LOWER FALLS IMPROVEMENT ASSOCIATION RIVERSIDE COMMITTEE

PRESENTATION TO THE ZONING AND PLANNING AND LAND USE COMMITTEES

September 23, 2019

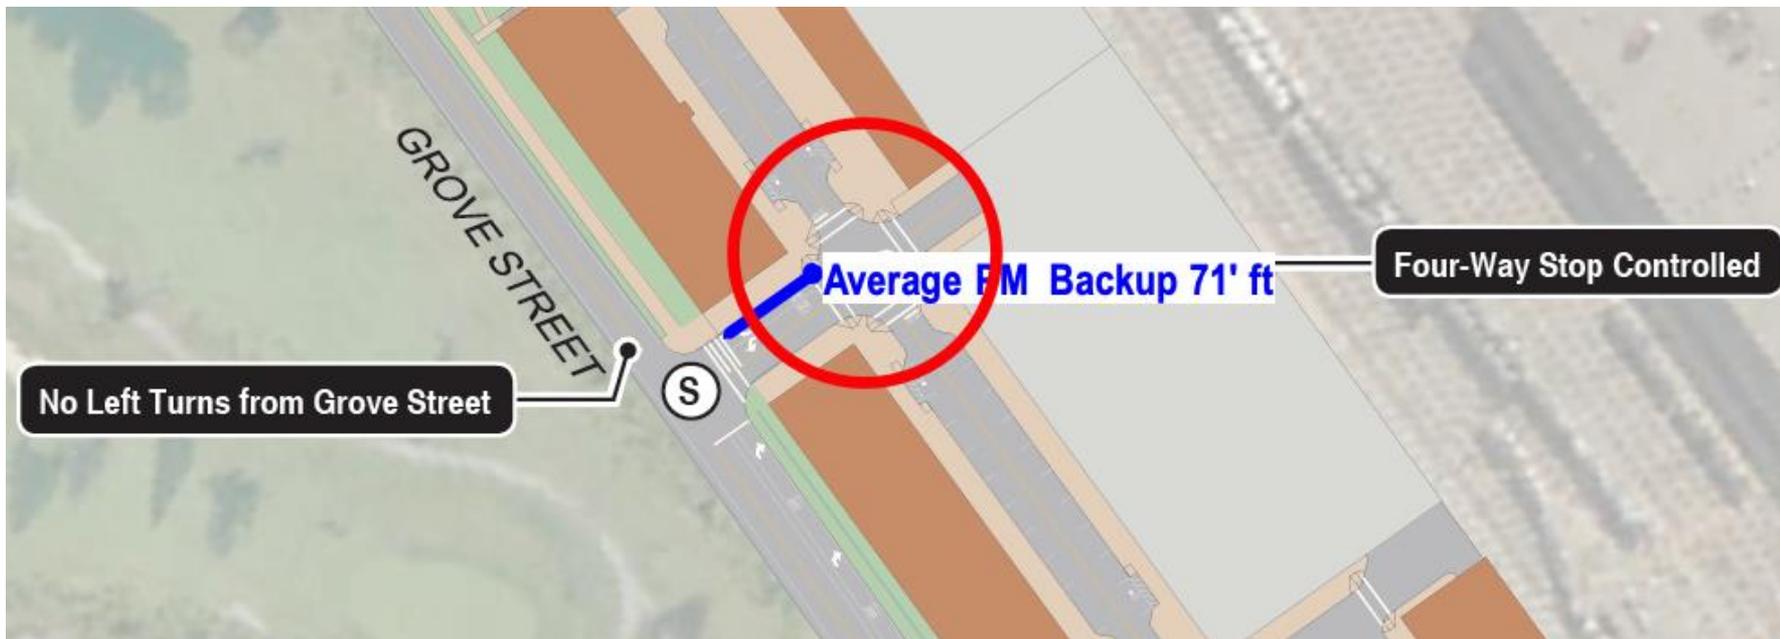
Evening traffic exiting to Grove Street may obstruct 4-way stop intersection if TNC, GLT & game day traffic included

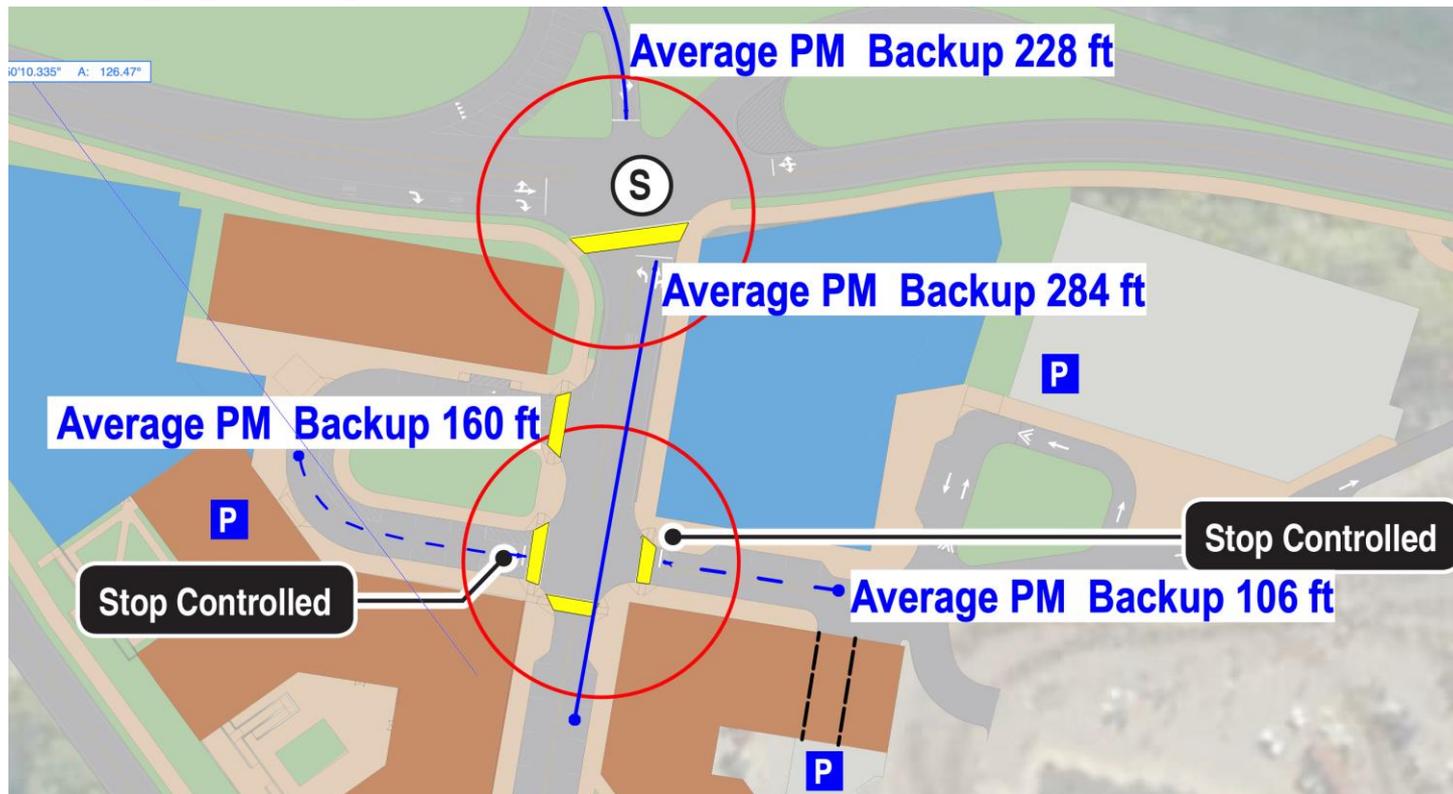
- Internal backups of 106 & 160 feet compound the external backup of 289 feet, trapping cars from exiting garage

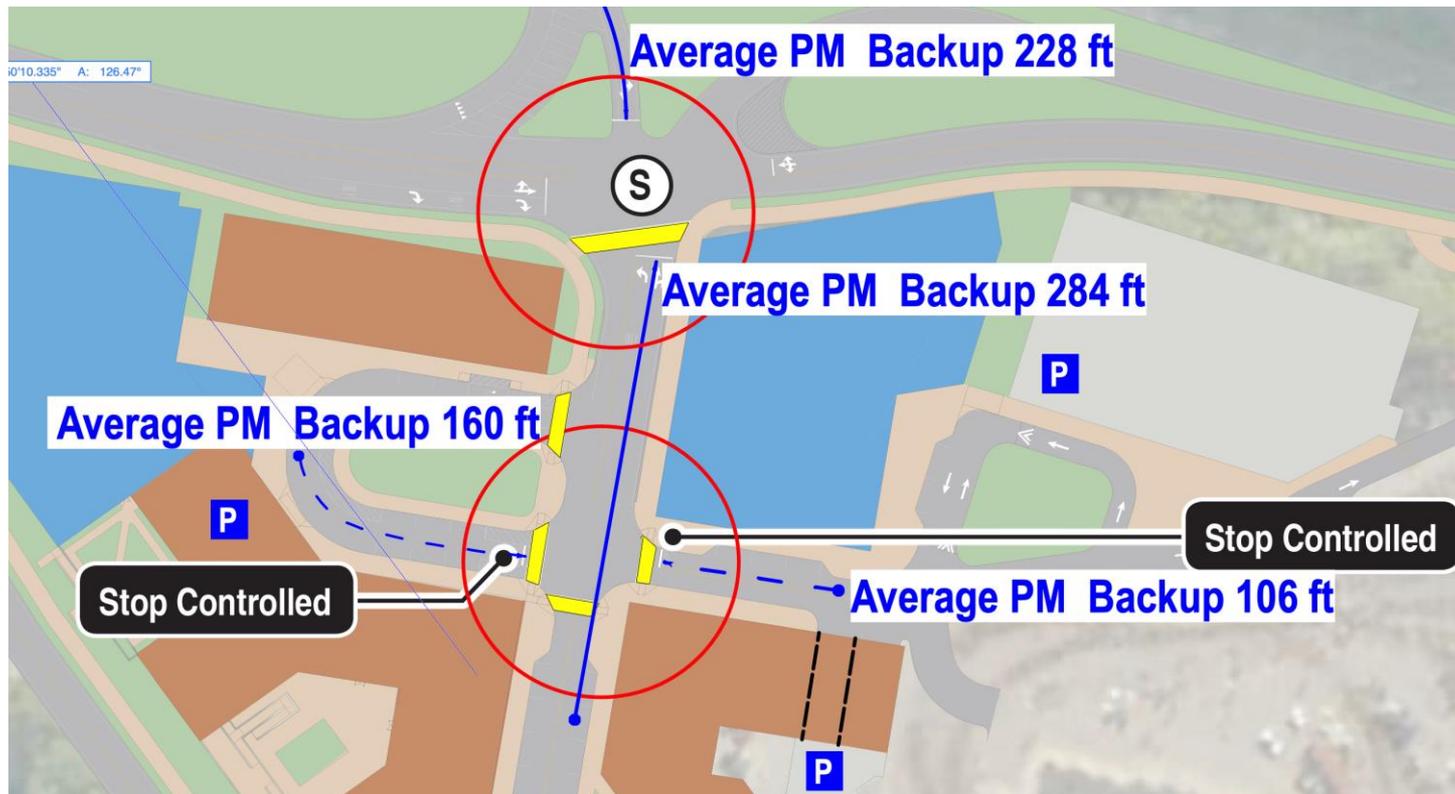
- ‘Shared parking’ will boost pedestrian travel across walkways, slowing vehicular egress

INTERNAL SITE TRAFFIC MUST BE ADDRESSED

Beneficial Open Space Plan

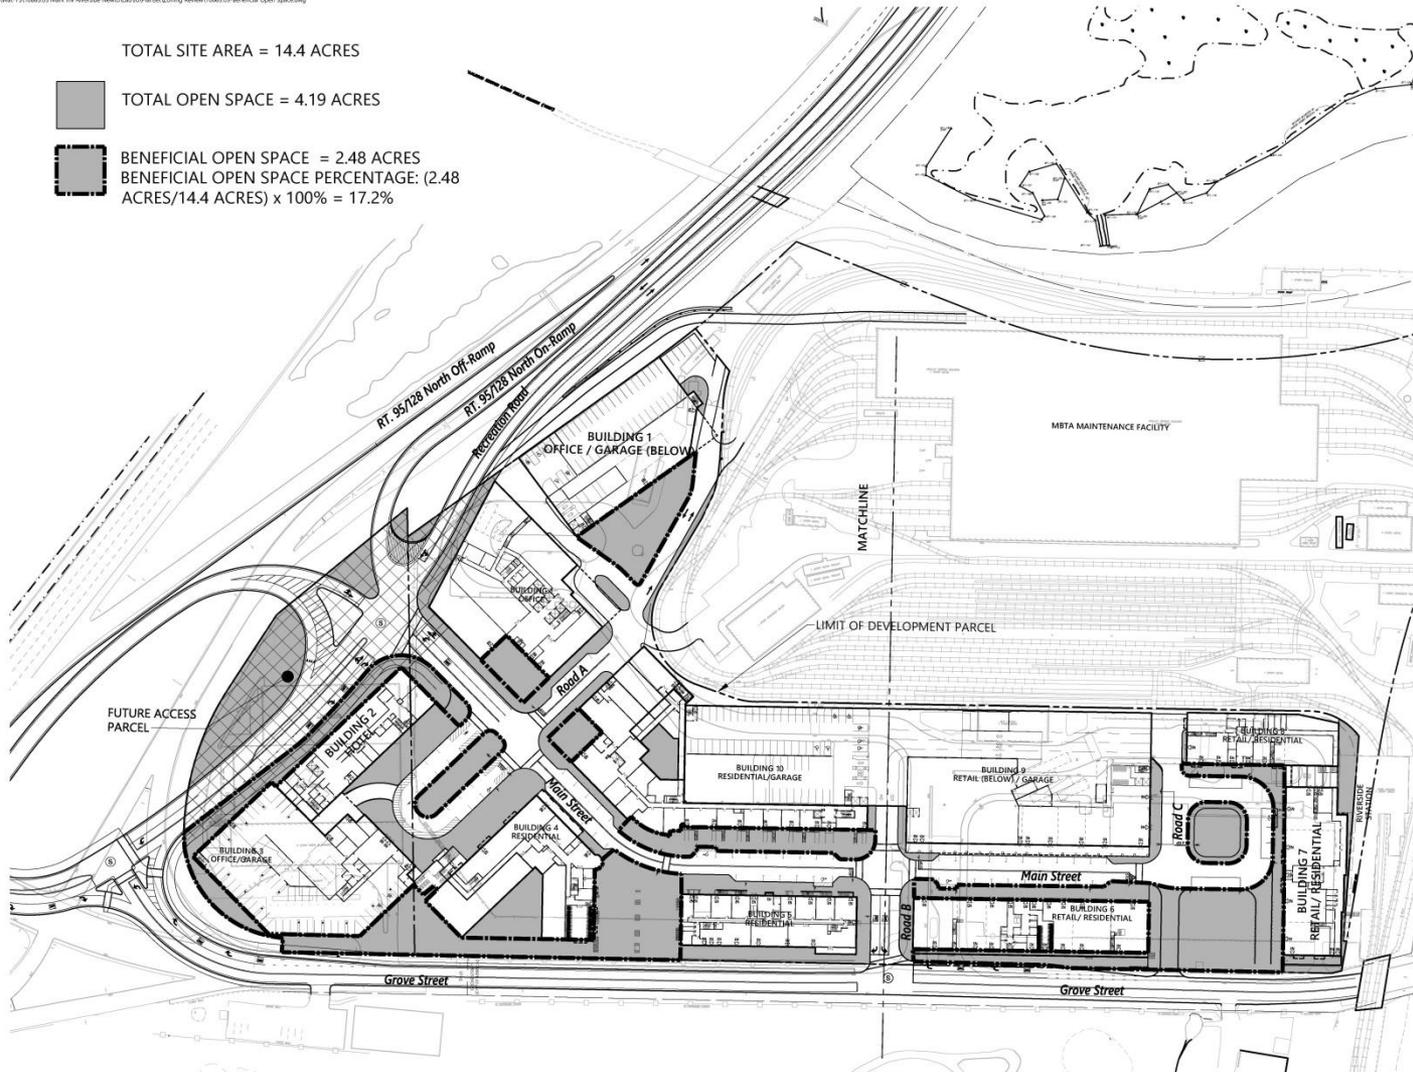
"BENEFICIAL" OPEN SPACE?
